# Geomorphology Report

## Proposed New Berrima Brickworks Facility at 416-524 Berrima Road, Moss Vale

For Brickworks Limited

16 April 2020

Figure 2. Concept drawing of a flow spreader at the downstream end of the proposed diversion channel (courtesy of Simon Haycock, AT&L).

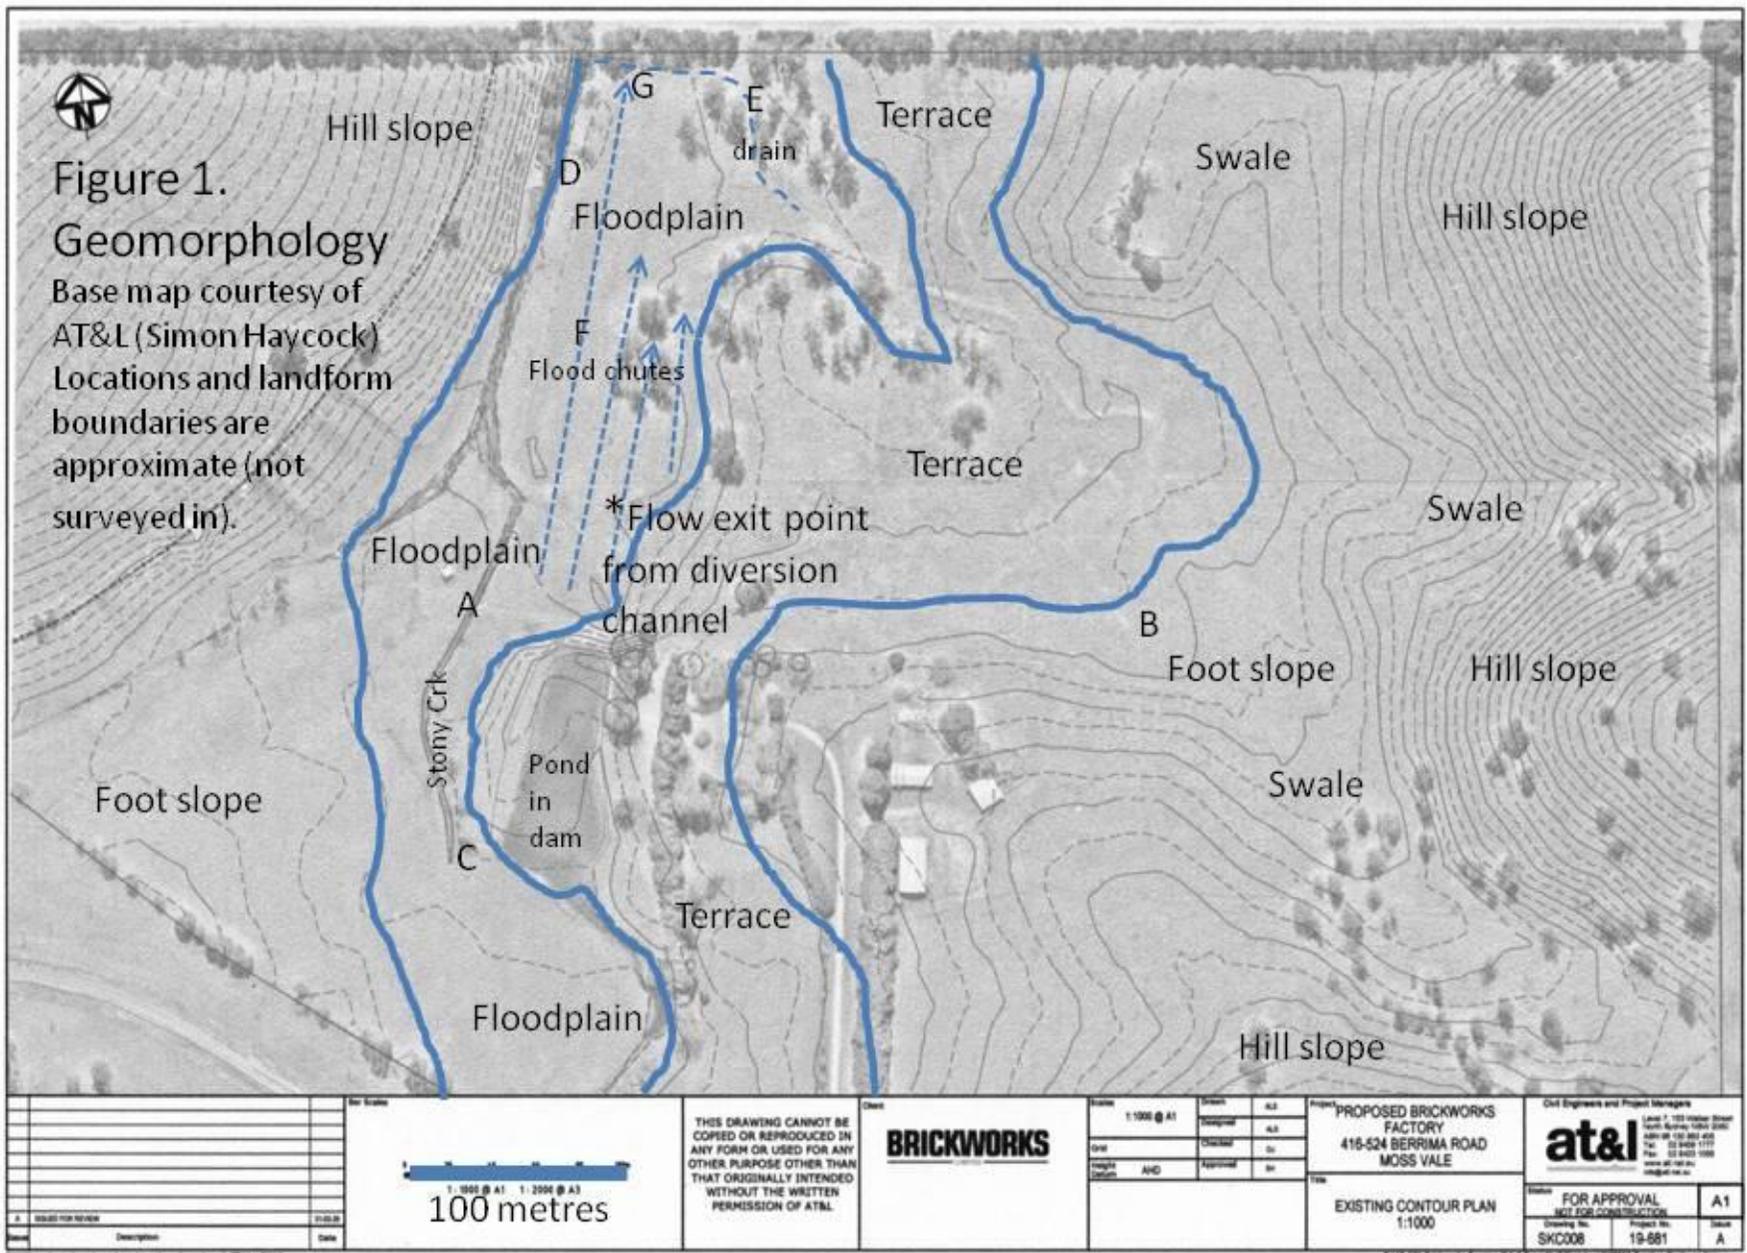
The drawings for the proposed diversion channel show that its downstream end is approximately 60m from Stony Creek and located on the creek's flood plain. I inspected this site and found the presence of 4 flood chutes (Figure 1). They are very shallow (less than 30cm deep), up to 1.5m wide at the bed and up to 3m wide at the top of the banks. Photo 6 is taken looking downstream along one such chute from site F on Figure 1. Flood chutes are linear depressions in a flood plain that run parallel to the stream channel and convey flood flow. They can be formed by scour or they may be prior stream channels that have been partially filled with sediment (Brierley and Fryirs, 2005).

If the flow exiting the proposed diversion channel travels down just one of the flood chutes, the flow may be concentrated enough to cause significant erosion. This could be prevented by spreading out the exiting flow to at least 20m in width so that it flows down at least 2 of the flood chutes. Figure 2 is a concept drawing of a flow spreader at the downstream end of the proposed diversion channel. A dense growth

of low-growing native plants such as *Lomandra longifolia* (spiny-head mat-rush) in the flood chutes and on the flood plain would also help to prevent erosion.

1. A flow spreading structure at least 20m wide should be constructed at the downstream end of the proposed diversion channel. This should be designed to reduce the exiting flow concentration, making the flow wide and shallow so that it flows overland down the slope of the flood plain and down at least 2 of the existing flood chutes.
2. The east bank flood plain overland flow area downstream from the diversion channel exit should be planted with closely-spaced low-growing native plants such as *Lomandra longifolia* (spiny-head mat-rush).
3. The diversion channel and the area downstream from its end should be monitored by inspection for erosion and sedimentation after each high flow event. Any problems should be rectified immediately.
